Lone Cedar Historic Barn
Hess –Hathaway Park
Bid Number: PR-17-01
Addendum #1
3/29/2017
Charter Township of Waterford

WEST ELEVATION

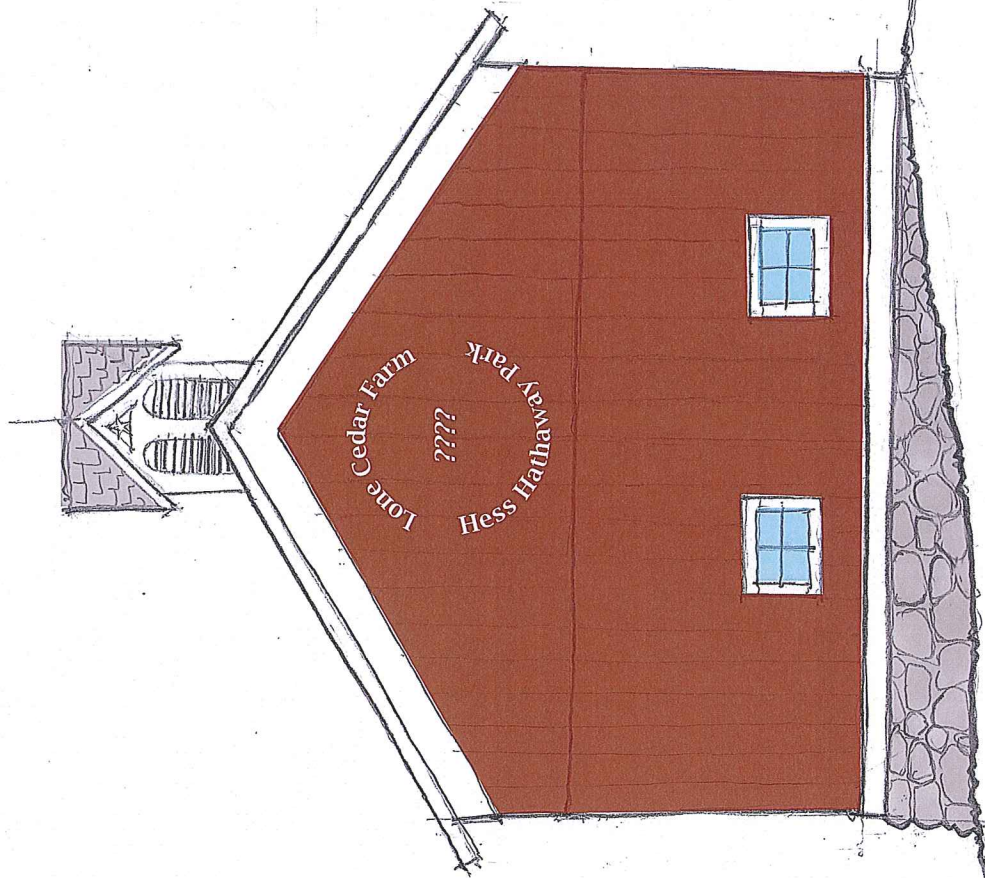
Item #6 – Painted sign on West Elevation

- A. An add alternate for a painted sign on the west elevation will be requested on the proposal form.
- B. Refer to the attached sketch for the sign placement and configuration.
- C. The font style is Lucida Bright, Demibold.
- D. The letter height of the upper case is 8 inches and the lower case proportional to the upper case.
- E. The diameter from the outer edge of the letters to the outer of letters is approximately 8 feet.
- E. Work is to be completed by a professional sign painter.
